Florida Power & Light Company  
St. Lucie Unit 2  
Docket No. 50-389

Subject: Response to NRC Request for Additional Information

**Individual Responses to NRC RAIs for FPL Generic Letter GL 2004-02  
Supplemental Responses, Dated 02/27/2008 and 06/30/2008**

Figure 6-1 Plot of velocity contour inside bioshield wall. High Flow

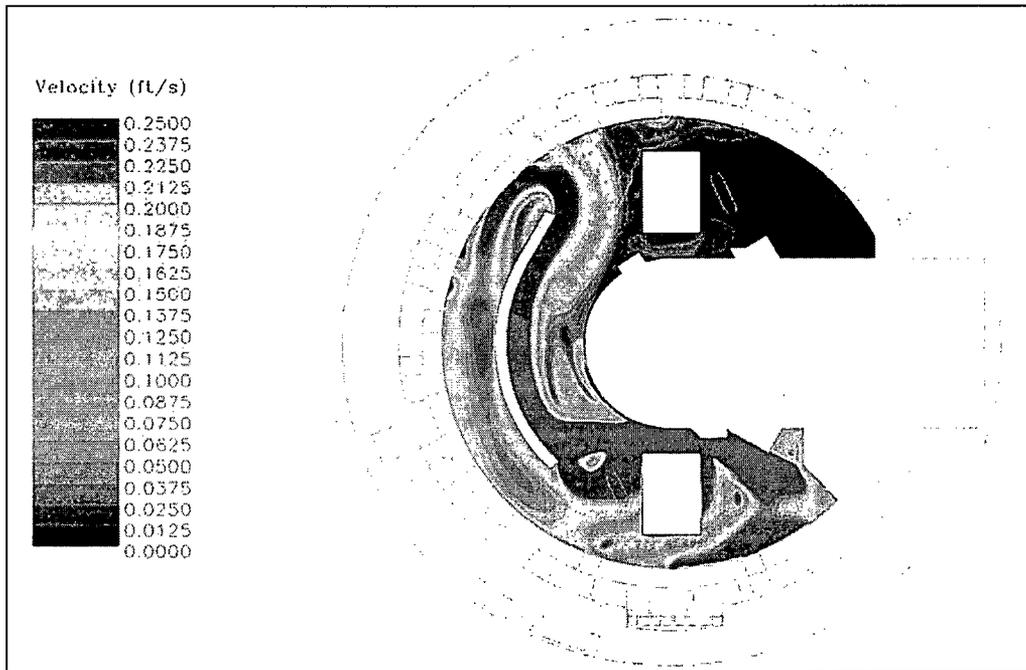
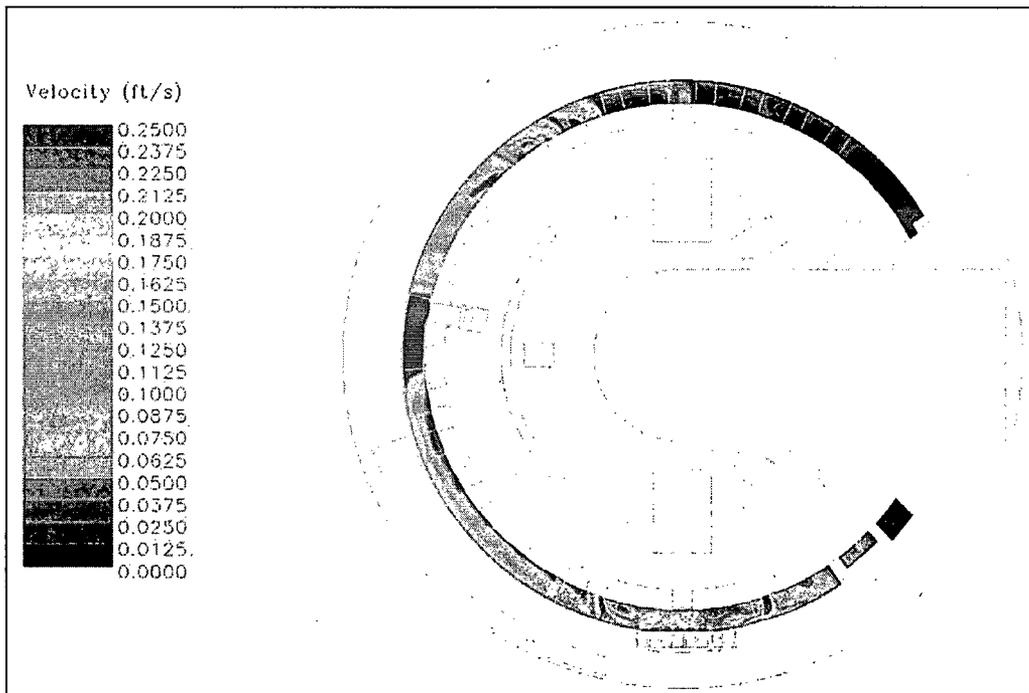
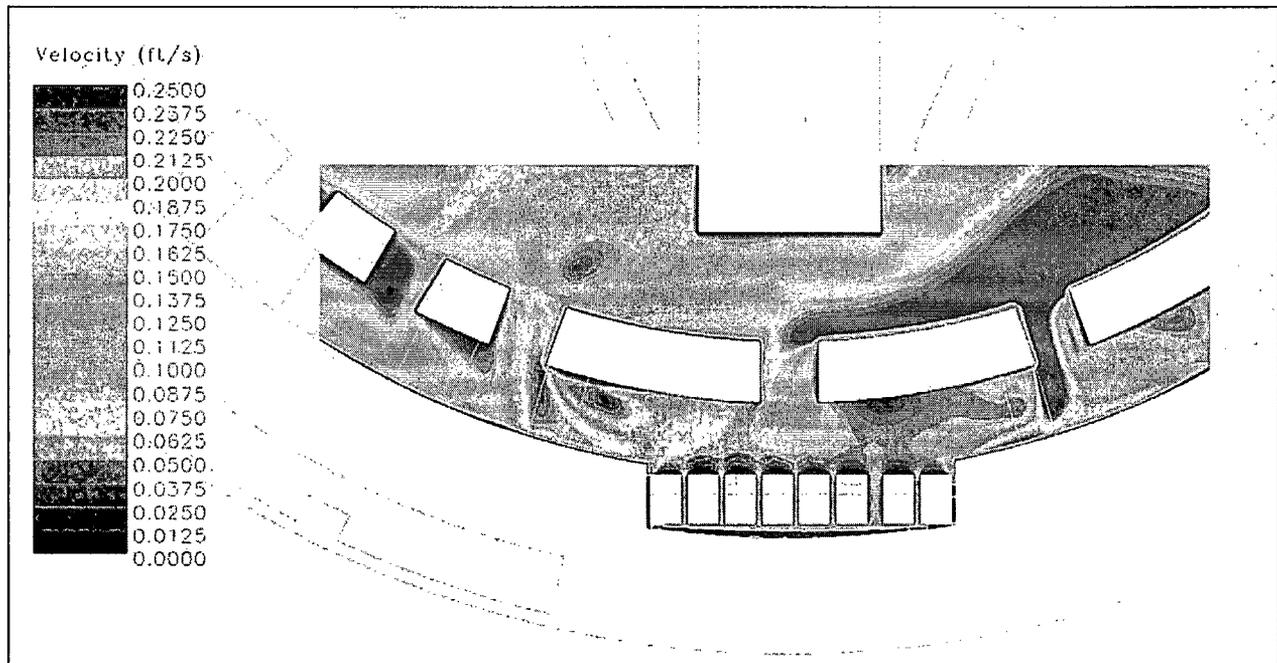
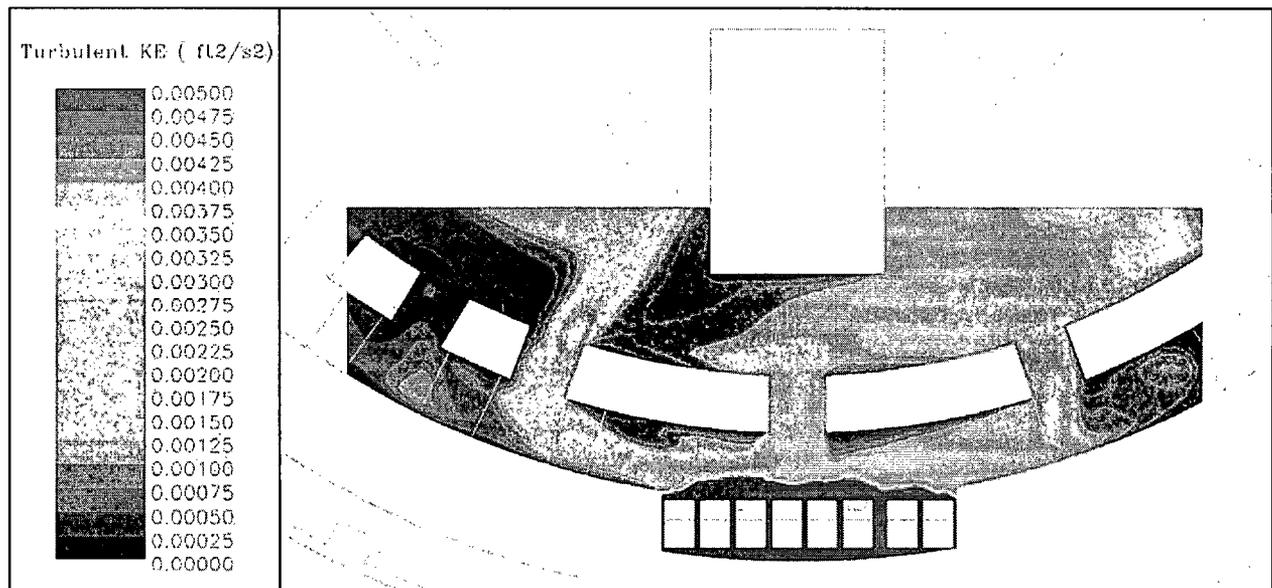
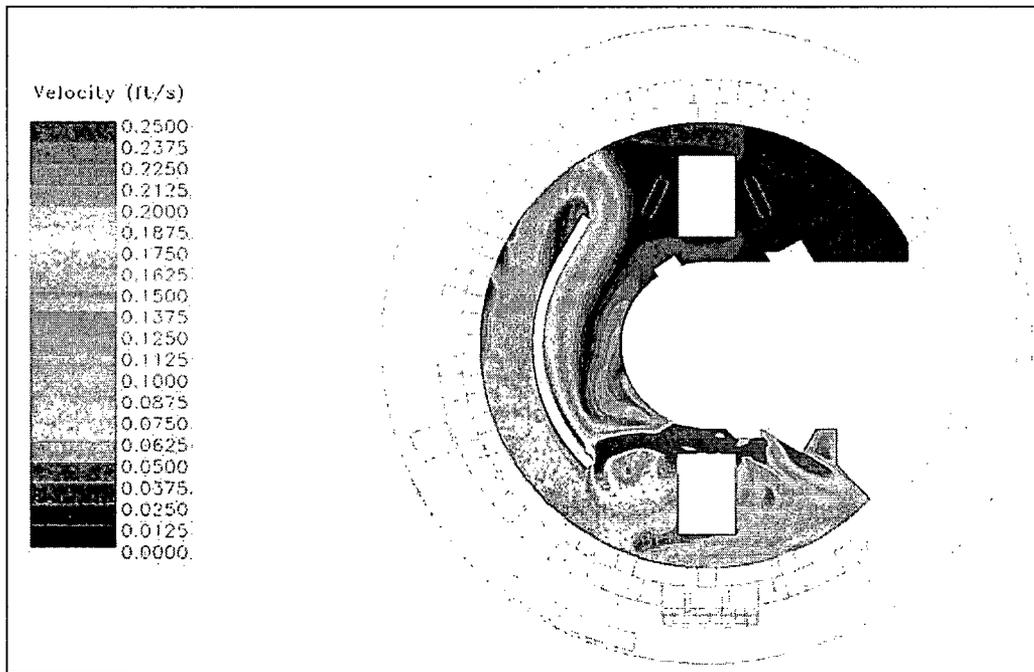
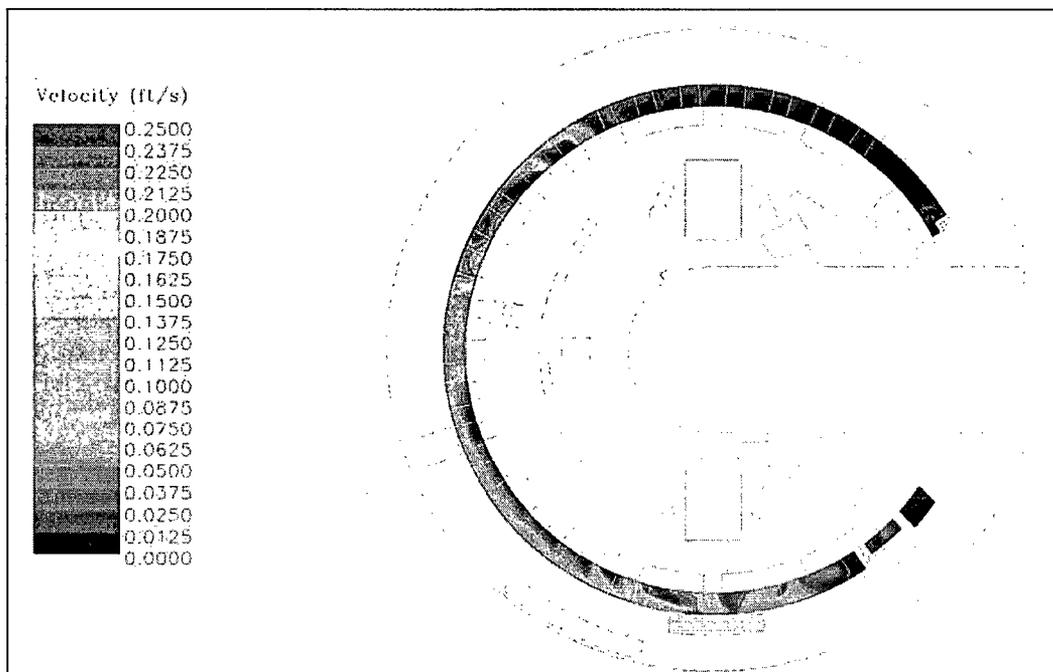
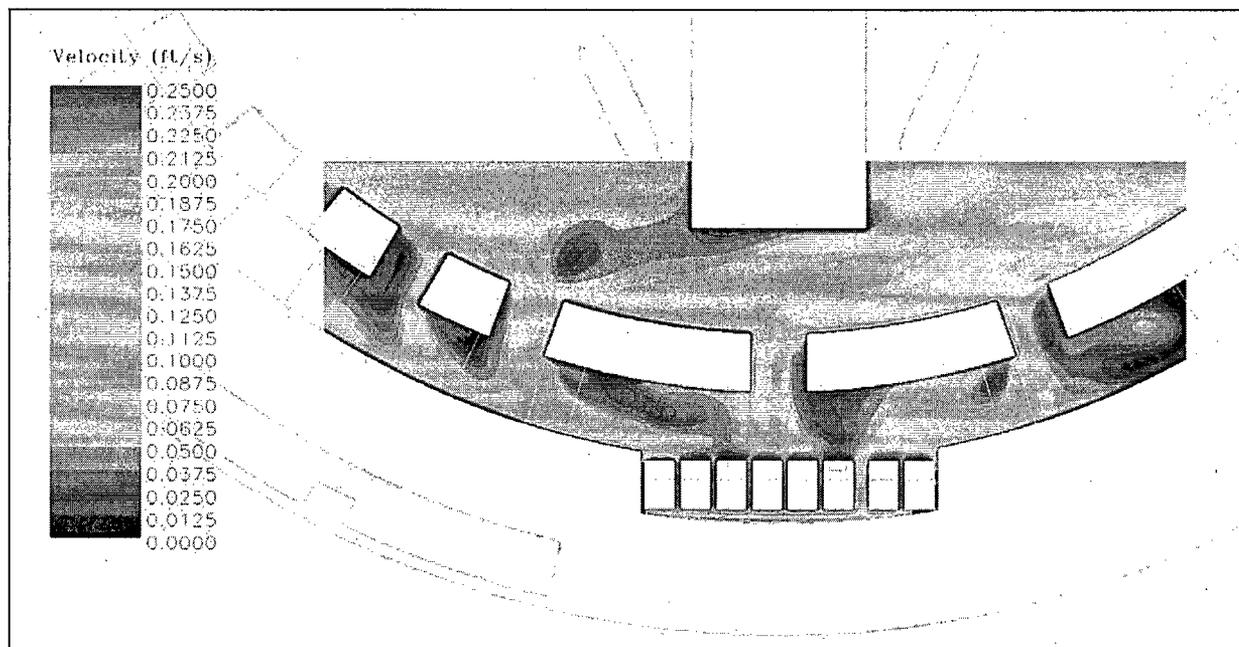
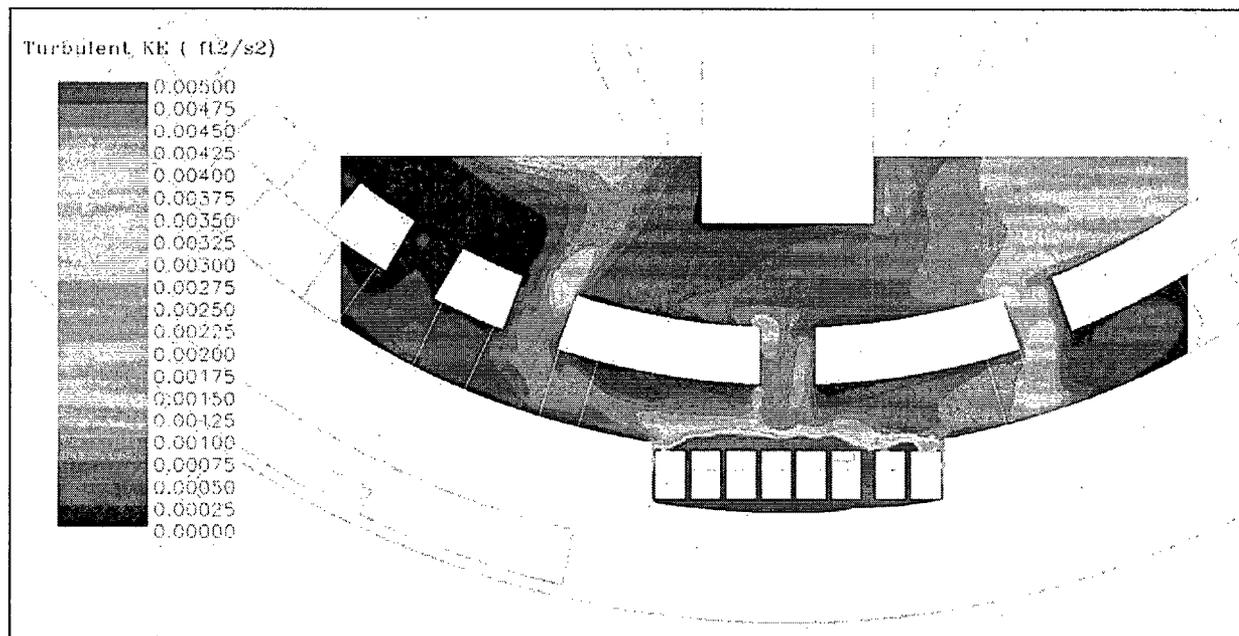
**RAI-6:** Provide a contour plot of the velocity for the containment pool inside the bioshield wall. Provide a contour plot of the velocity in the emergency core cooling system (ECCS) trench. Provide a close-up plot of the velocity and turbulence contours in the region of the strainer and its immediate vicinity. Provide a table of the head loss test flume average velocity as a function of distance from the test strainer and identify the turbulence level simulated in the test flume.

**RAI-6 RESPONSE:** The contour plots, Figures 6-1 through 6-8, requested are shown below. Additional turbulence, above that which is associated with the shear in the flow as the water approaches the strainer in the test flume, was not implemented. Tables 6-1 (LPSI failure to trip case) and 6-2 (Design Flow case), test flume velocity vs. distance from strainer module, are also shown below.

Figure 8-1: Streamlines for Scenario: Particles Released from Sump

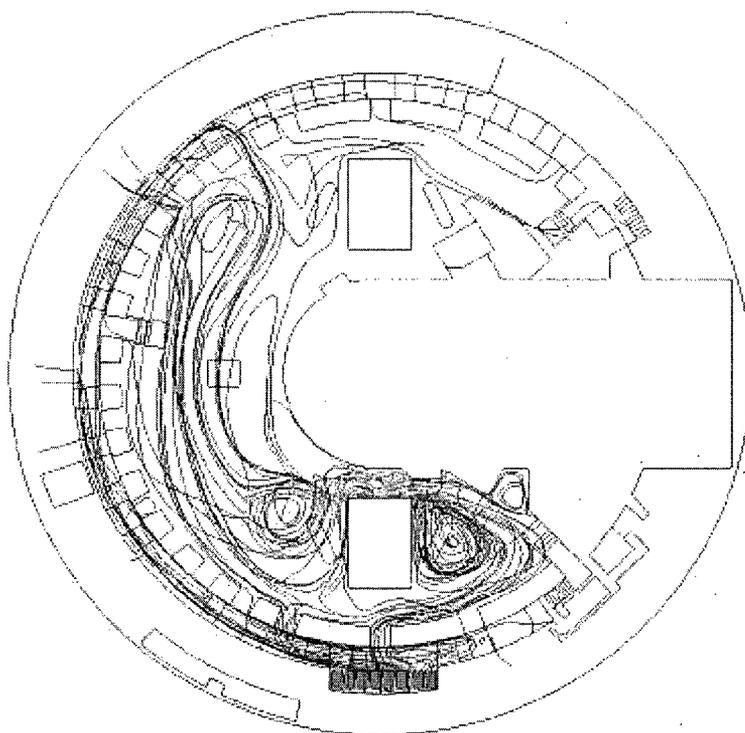
**RAI 8:** Provide the general methodology used to determine the average flow to the strainer modules. In doing so, provide added detail concerning how the flow velocity in the ECCS trench approaching the modules from each side of the modules was “averaged” with the flow approaching from the shield wall openings in front of the modules. Identify the “four flow streams” discussed on page 20 of the supplemental response.

The four flow streams are the flow paths to the strainer. Refer to Figure 8-1 below. The flow approaches the strainer from four directions, from the trench on each side of the strainer and from the two nearest openings in the SBS wall.

Figure 12-1: Small Debris Logic Tree for Blast, Wash Down, and Pool Fill

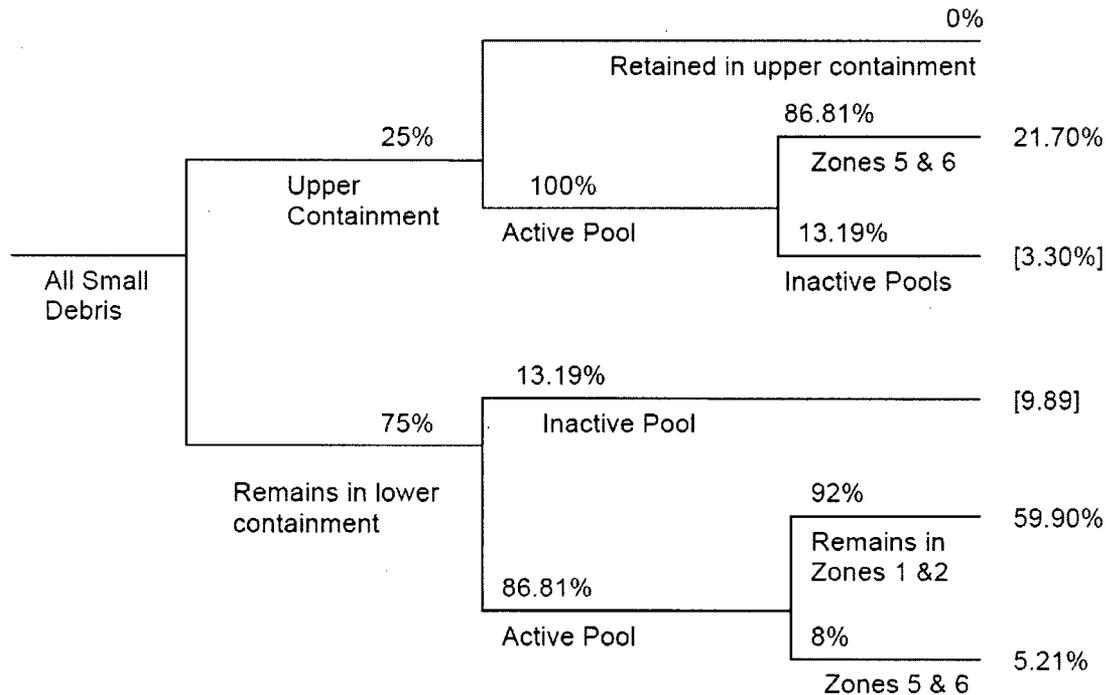
**RAI-12:** Describe the methodology and technical basis for the conclusion that 23% of the calcium silicate debris settles in the containment pool. State the size distribution of the calcium silicate that is assumed to settle in the containment pool.

**RAI-12 RESPONSE:** The basis for determining the total percentage of calcium silicate debris that settled out in the containment pool is documented in “St. Lucie 2 Nuclear Plant (PSL2) – Debris Transport” calculation. Based on the blast, washdown, and pool fill phases 13.19% of the calcium silicate debris is sequestered in inactive containment sump volumes.

Figure 15-1

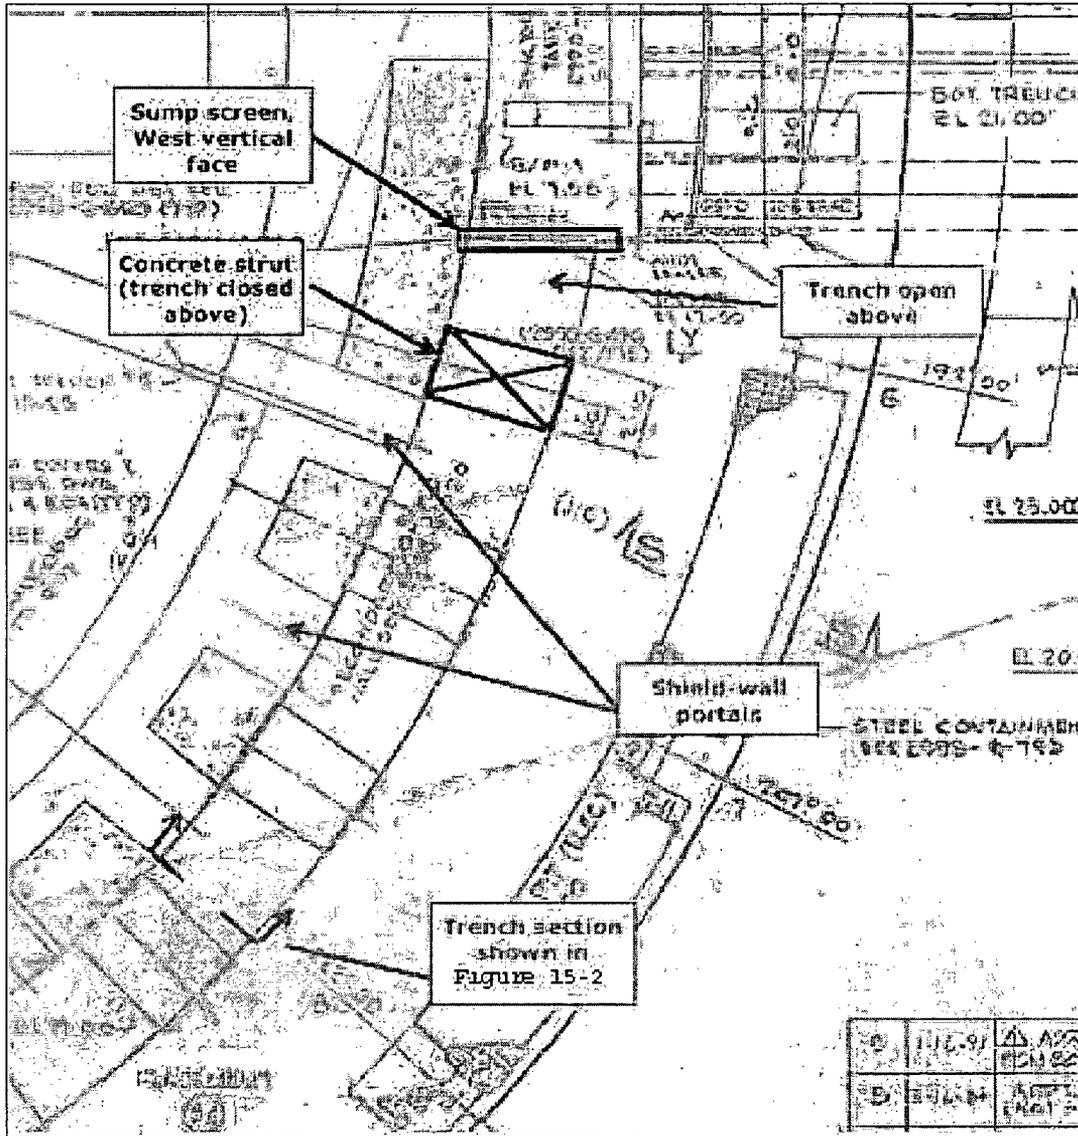
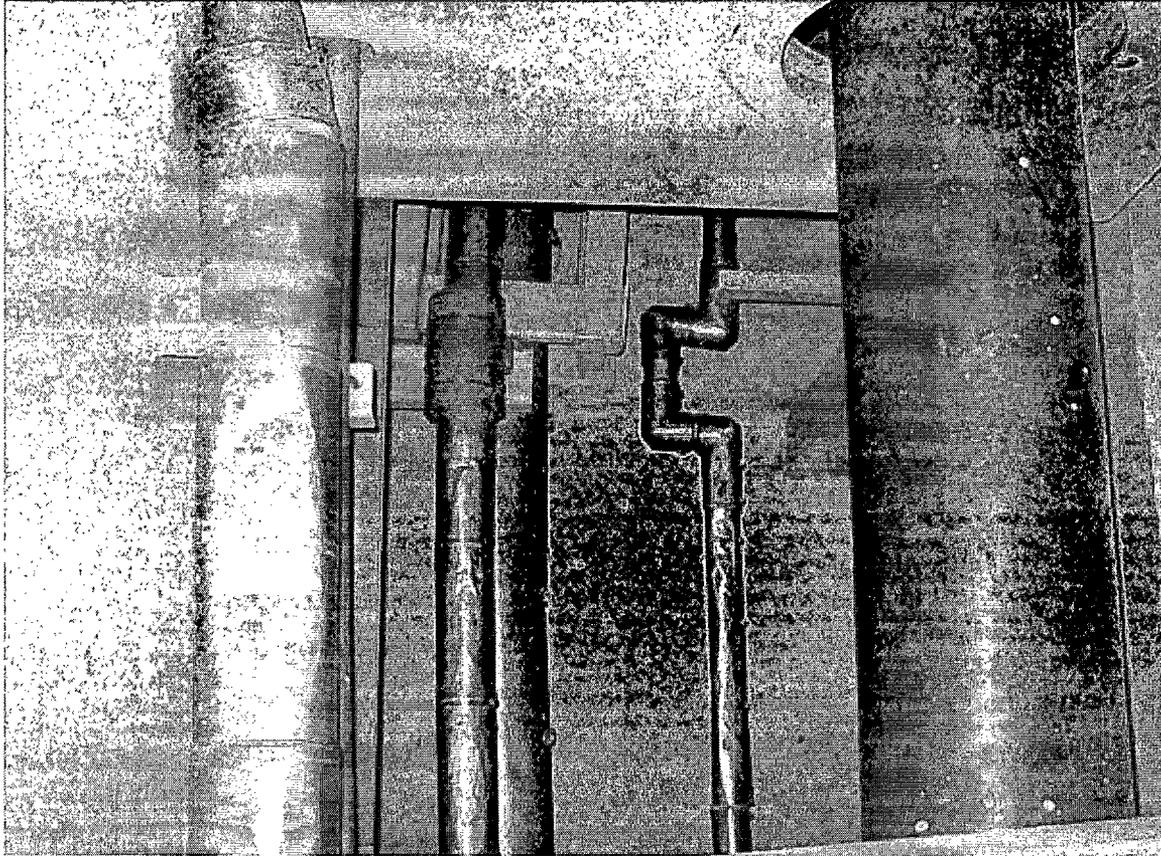
**RAI-15:** In the upstream analysis, the supplemental response states that chokepoints in the ECCS trench are not an issue because large pieces of debris will not enter this trench due to the presence of trash racks around the bioshield wall. However, the supplemental response did not address the potential for large debris to be blown into upper containment and then washed down by containment sprays outside of the bioshield wall downstream of the trash racks. Provide a basis to justify that blockage in the ECCS trench will not occur in light of the phenomenon discussed above.

1. The ECCS trenches are located around 270 circumferential degrees of containment just outside of the SBS wall (see figure 15-1 below). Much of the trench is covered by grating or floor which would restrict the intrusion of large debris. Should a portion of trench be partially or totally blocked at some point, numerous alternative flow paths to the ECCS strainers remain.

4. Since the ECCS trenches contain some piping supports and equipment, it is very improbable that debris of such size and exact geometry could pass into and completely or significantly block a trench due to interfering piping or equipment (see figure 15-2).

7. Finally, the smallest cross section of the ECCS trench is 5 ft. wide by 7 ft tall. Such a cross section would require quite a large perfectly placed section of debris to disrupt flow. The trench cross section becomes deeper as the strainers are approached (see figure 15-2 for a photograph of the trench).
